Department of Energy

RESPONSE TO COMMENTS ON SILO 3 PROJECT SITE PREPARATION PACKAGE

RESPONSES TO OHIO EPA AND U.S. EPA COMMENTS ON SILO 3 PROJECT 100% SITE PREPARATION PACKAGE

SIL0 3 PROJECT
FEMP
GRADING AND DRAINAGE PLAN

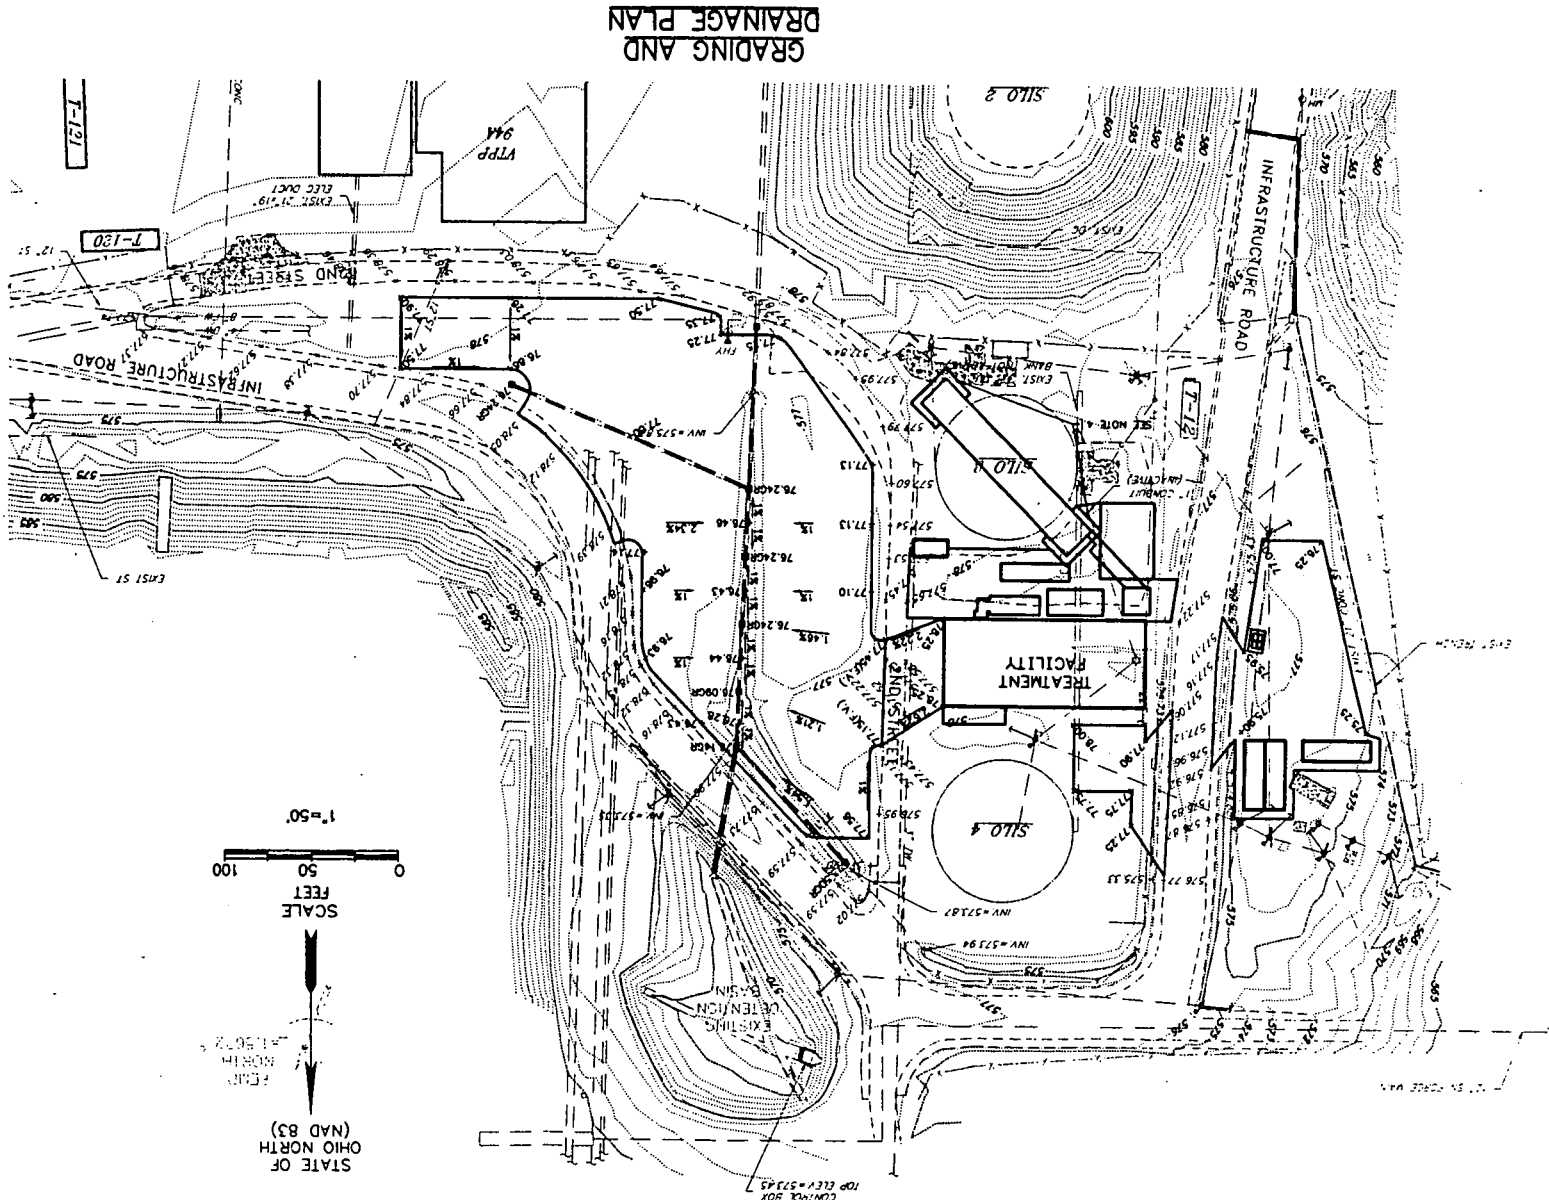
Item	Commentor	Page/Section	Comment	Response
1	OEPA - OFFO	General comment	Paving of areas west of the silos may increase surface water run-off to the surface water containment trench. Will the existing trench provide adequate drainage for increased run-off?	The areas west of the silos are to be gravel over existing ground resulting in a small increase in runoff. The capacity of the existing trench is adequate to provide for this increase.
2	OEPA - DSW	Section 3 Pg. 2 of 5 Line #21-22	Sewage tanks need to have an alarm and be shut down when full.	Will revise as commented.
3	OEPA - OFFO	Pg. 2 Line #37	It is Ohio EPA's preference that in all possible instances bioengineering materials such as coir matting or vegetation be used to replace reliance on rip rap.	Agreed. Wherever possible, the design of storm water runoff and erosion control measures for the Silo 3 project utilizes materials such as coir matting or vegetation to stabilize disturbed areas rather than rock or riprap.

SILO 3 PROJECT
FEMPEROSION CONTROL
PLAN

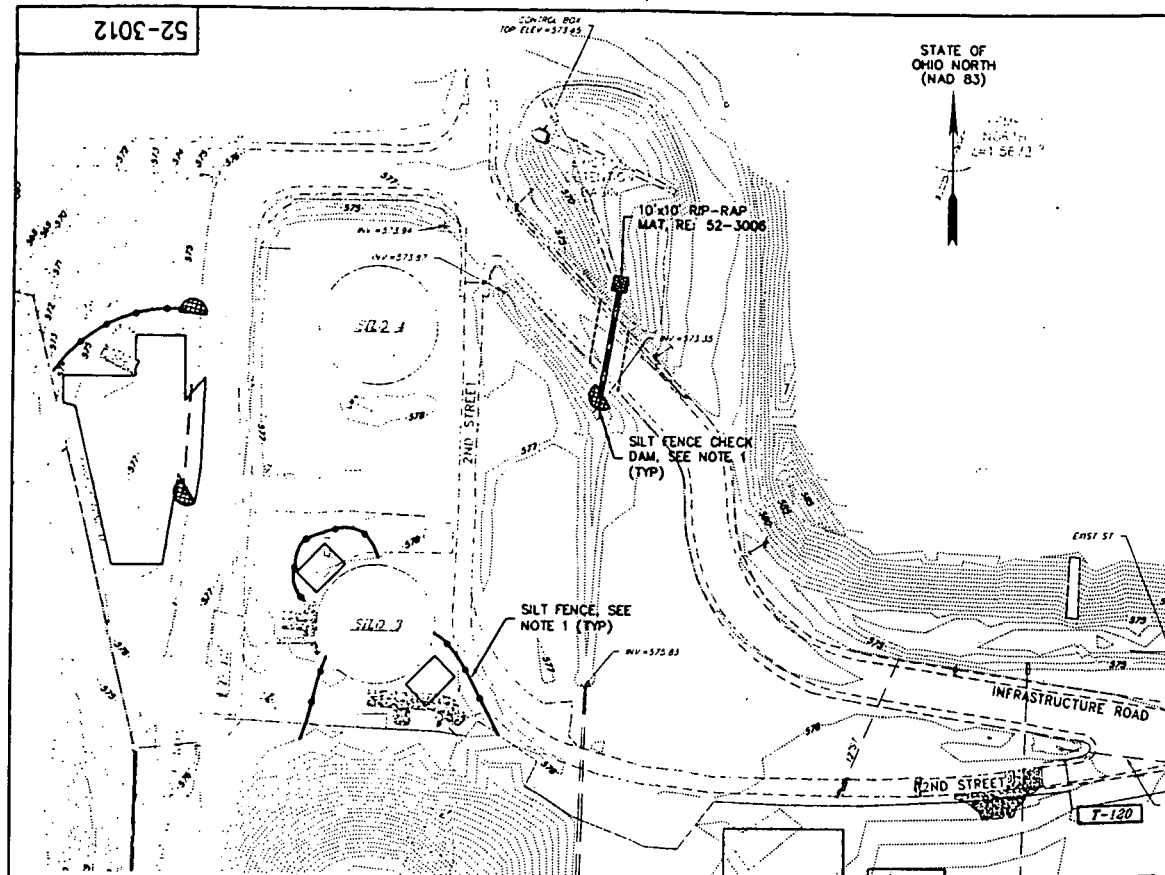
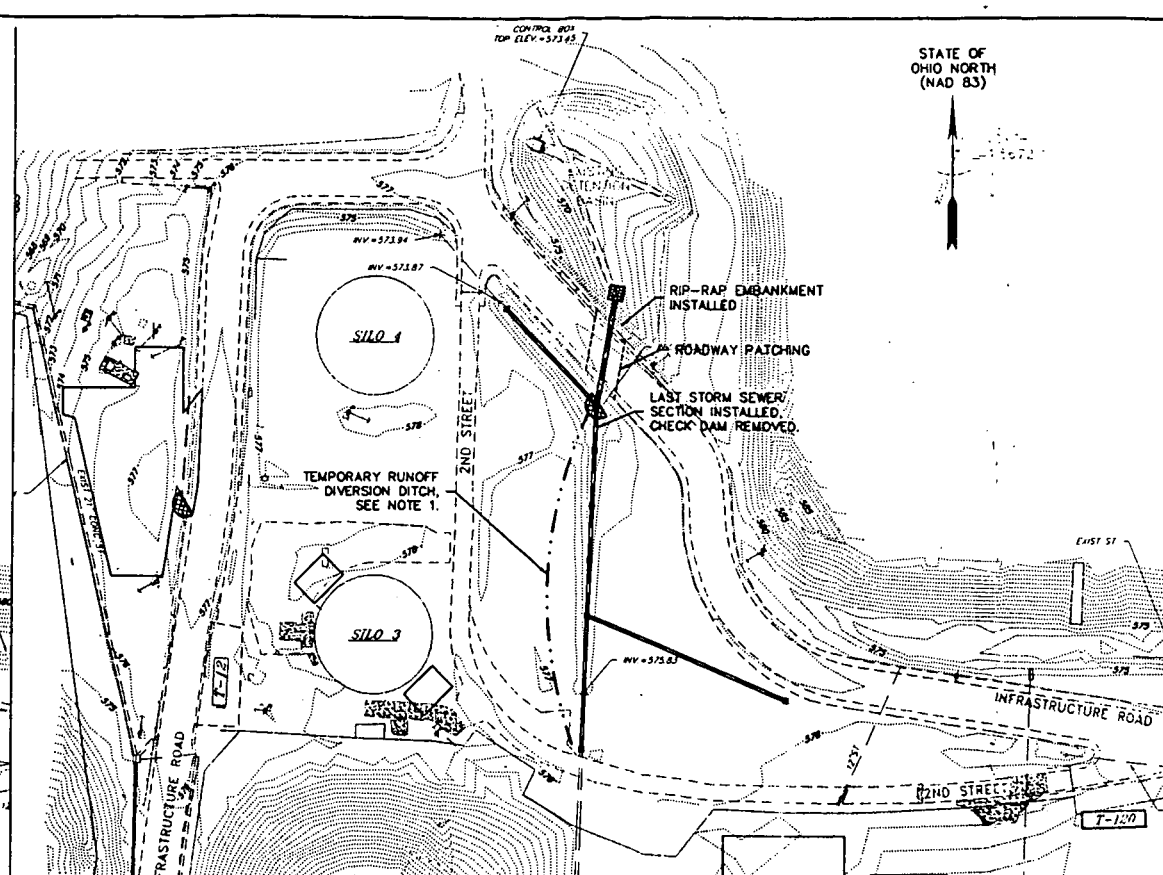
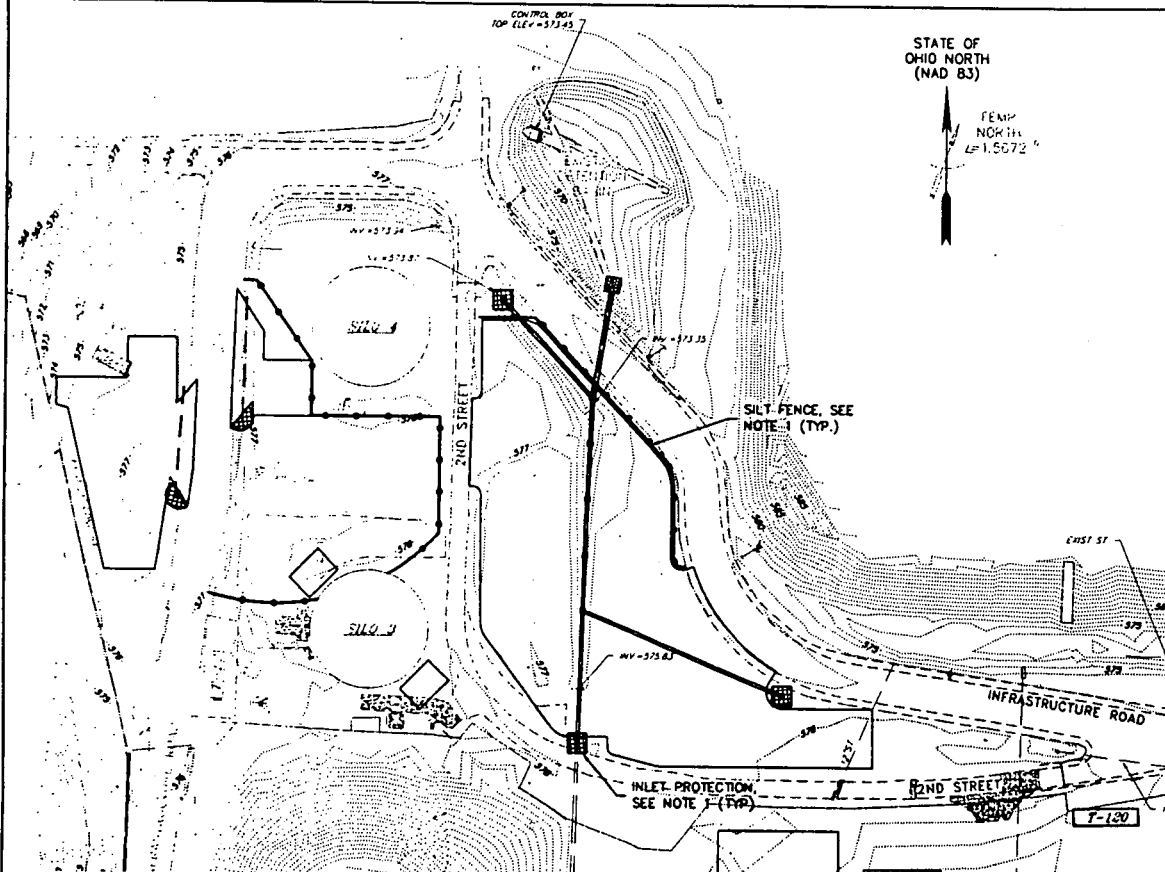
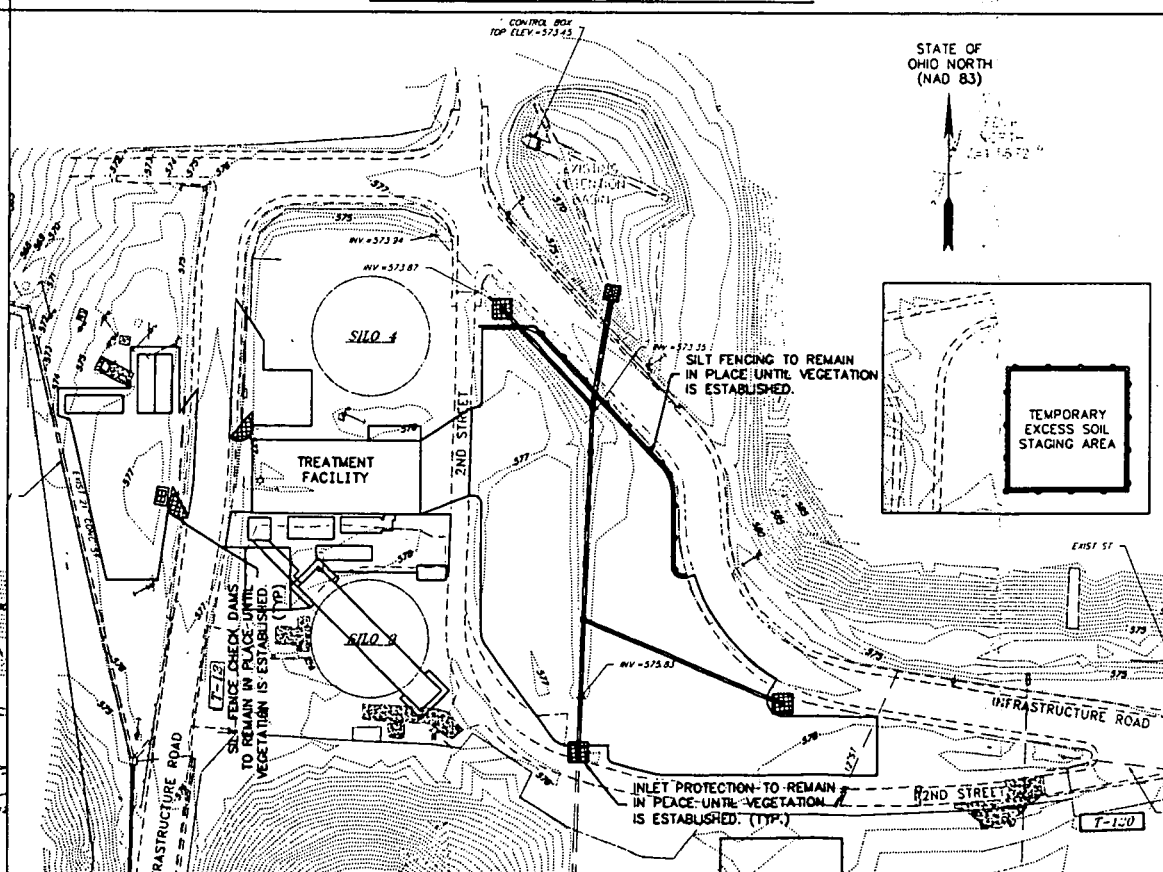
11	OEPA - OFFO	Section 4.4 Pg. 16	All efforts should be made to prevent the stockpiling of above WAC soils. If all other efforts fail, above WAC stockpiles must have liner material placed below them and a tarp on top.	Agreed. The Waste Management Plan section of the Pre-Operational Environmental Control plan has been rewritten to clarify plans for management and disposal of excess soil. Any above-WAC soil will be transported to SP-7.
12	OEPA - OFFO	Drawing 52-3012	The lower left figure appears to show silt fence running through silo 3. The drawing should be revised to show silt fence properly installed along the contours.	Will revise as commented.
13	OEPA - OFFO	Drawing 52-3012	The addition of a legend to the figure showing the various symbols and definitions would be helpful.	Will add legend.
14	OEPA - OFFO	Drawing 52-3013	Cross section A should show silt fence installed at the vegetated slope.	Will revise as commented.

SILO 3 PROJECT
FEMPISA - PAVEMENT
PLAN & SECTIONS

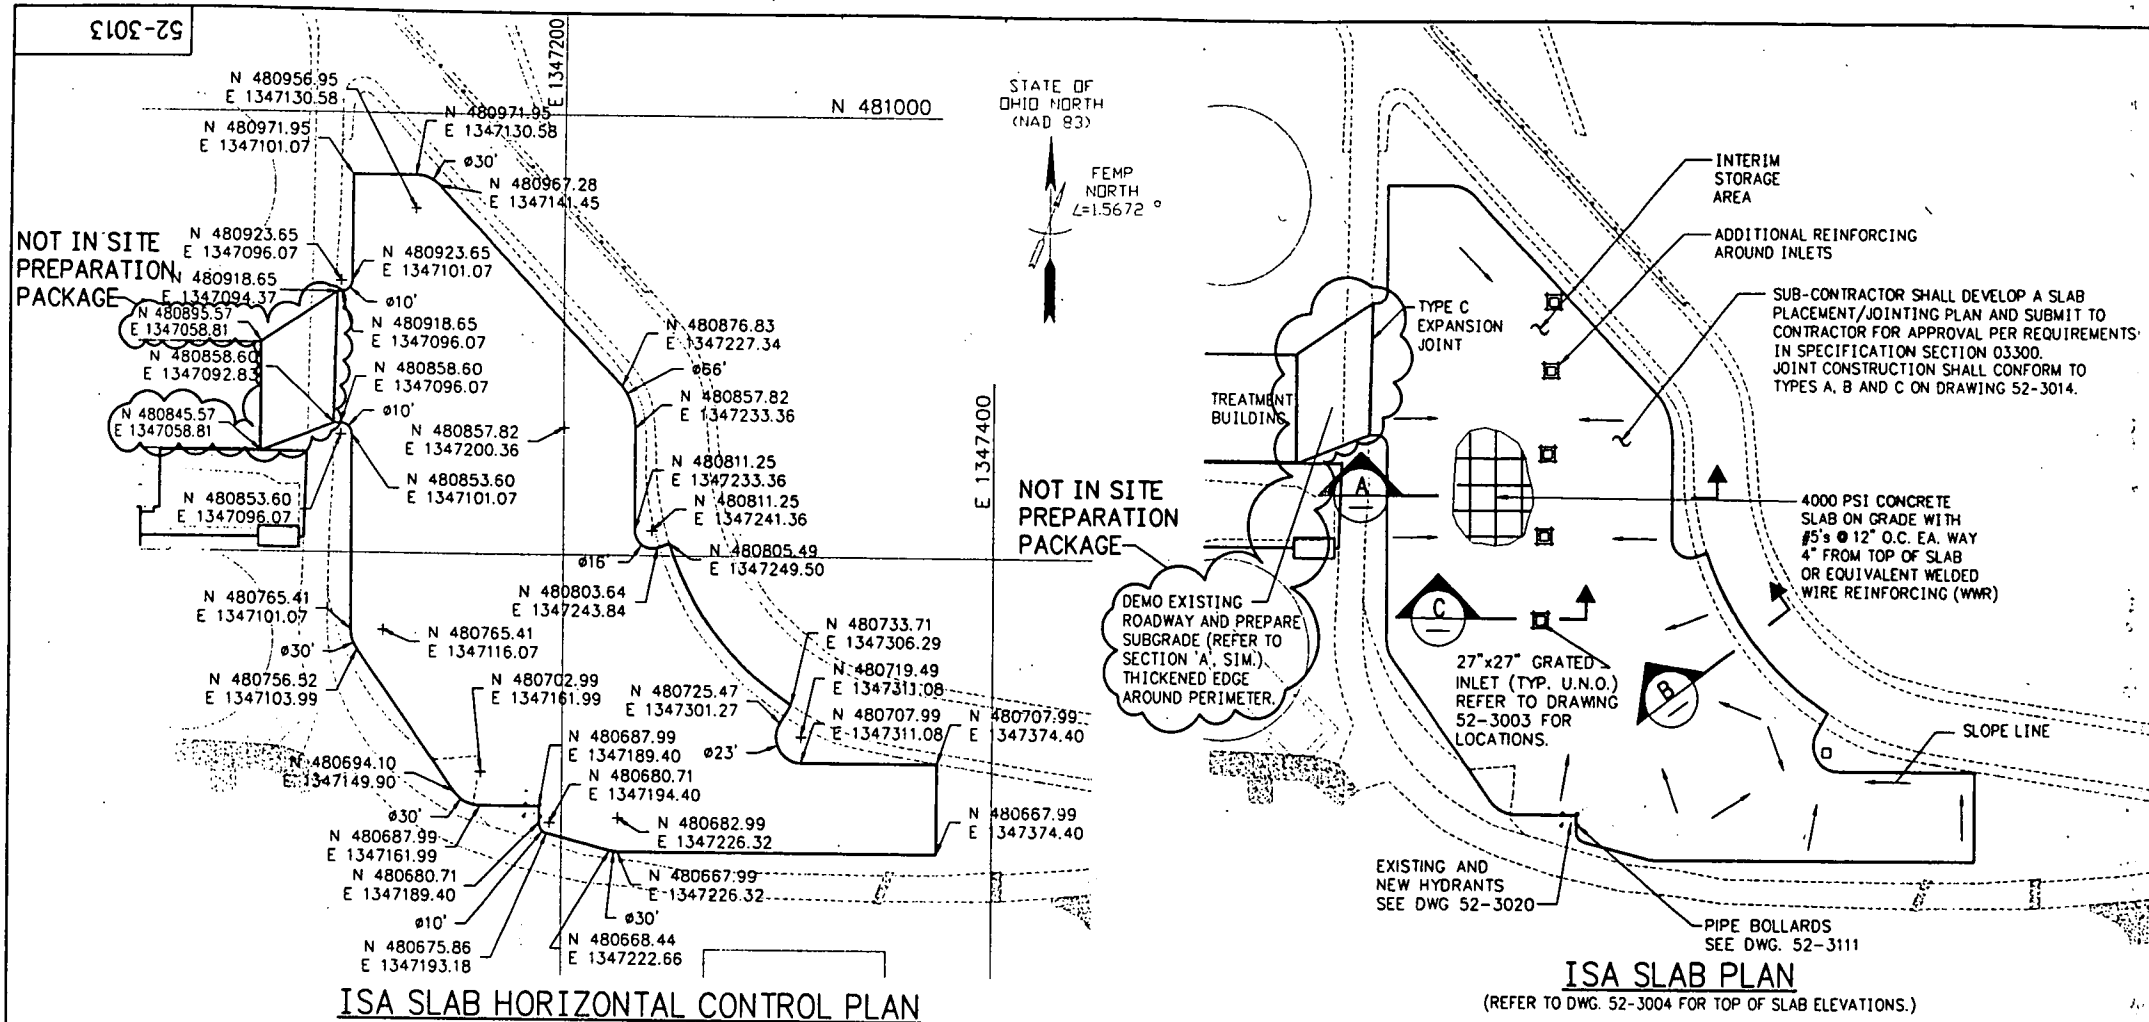
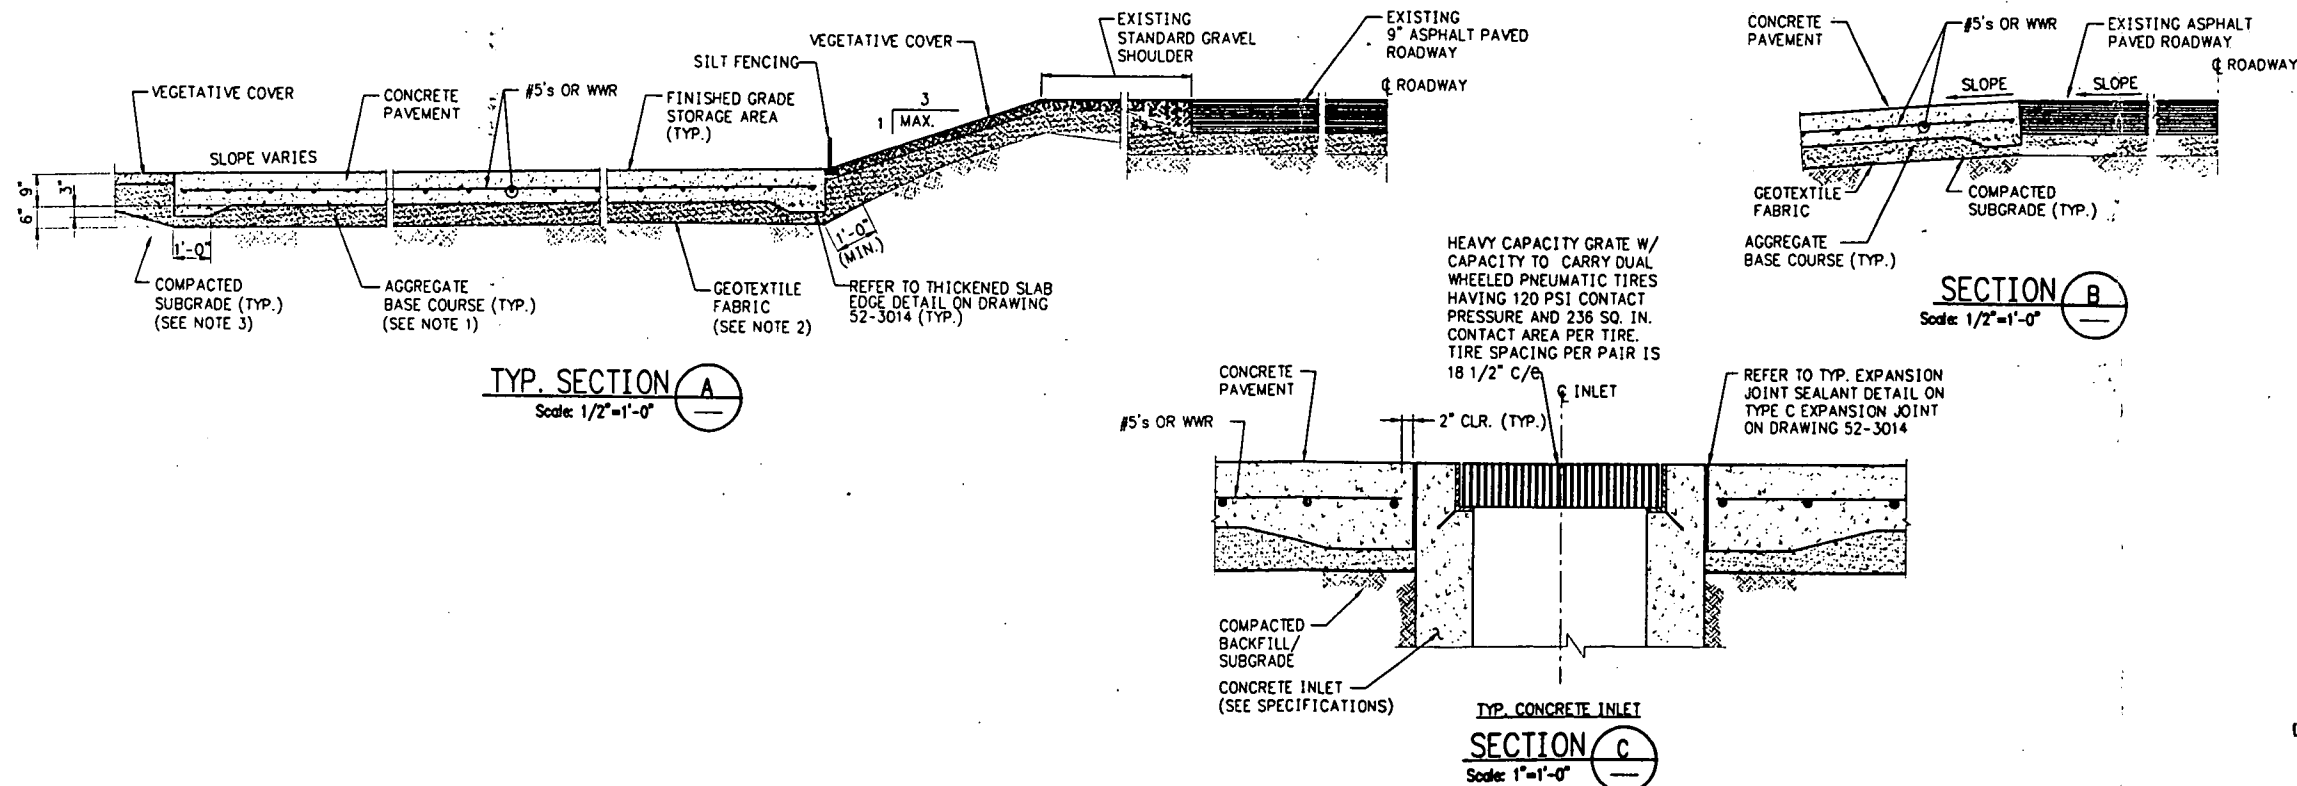
15	OEPA - OFFO	Drawing 52-3013	Ensuring good drainage across the storage pad is paramount. It will not be acceptable to store loaded waste containers in standing water.	Agreed. The ISA Pad has been designed to drain into new catch basins which will drain to the existing detention basin north of the pad. Drainage calculations demonstrate that the capacity of the drainage system is sufficient to ensure that standing water will not accumulate on the pad during storm events. In addition, the design calls for the loaded containers to be stored on pallets to provide further protection from contact with water on the pad.

16	OEPA - OFFO	Drawing 52-3013	Ohio EPA is taking this opportunity again to state that this storage pad as designed will not be an acceptable replacement for the Plant 1 Storage Pad. DOE had previously suggested this may be used in the future as a replacement for Plant 1 storage this will not be acceptable.	<p>The storage pad is being constructed for interim storage of stabilized Silo 3 material pending shipment to the disposal facility. The design meets all substantive requirements of RCRA and other ARARs for storage of wastes not containing free liquids.</p> <p>The only identified use of the pad after completion of the Silo 3 project would be for potential storage of solid wastes currently stored on the Plant 1 Pad.</p> <p>It is recognized that other future uses for the pad, such as storage of liquid wastes, would require either modification of the pad, or installation of temporary secondary containment. Any such use of the pad, and the necessary modifications, would be reviewed in advance by OEPA and U.S. EPA.</p>

27	USEPA REGION V, Specific Comment 2	Drawing 52-3013	<p>The drawing shows the construction of a concrete slab for the interim storage area, which has a number of stormwater inlets. It is not clear from this drawing how the stormwater sewer will be protected from spills of contaminated waste, soil, or other materials if an accident occurs. Typically, storage areas for hazardous waste materials are contained to prevent any potential contaminant migration off site into surface water. This design should be revised and modified to show such containment.</p>	<p>The ISA pad is designed for storage of treated Silo 3 material awaiting shipment to the disposal facility. No liquids, nor waste containing free liquids will be stored on the pad. Therefore, secondary containment (curbing, etc.) is not required so long as the containers are protected from contact with accumulated precipitation (OAC 3745-55-75(C)).</p> <p>The design of the pad will prevent any liquids spilled on the pad from migrating to off-site surface water. Precipitation or other liquid on the pad will drain to a storm sewer line discharging to the retention basin north of the pad. This retention basin discharges to the Waste Pit Area Stormwater Runoff Control Sump Northwest of Silo 4. Contaminated stormwater runoff from the Silos and waste pit areas collected in this sump is treated through the FEMP wastewater treatment system prior to discharge.</p>
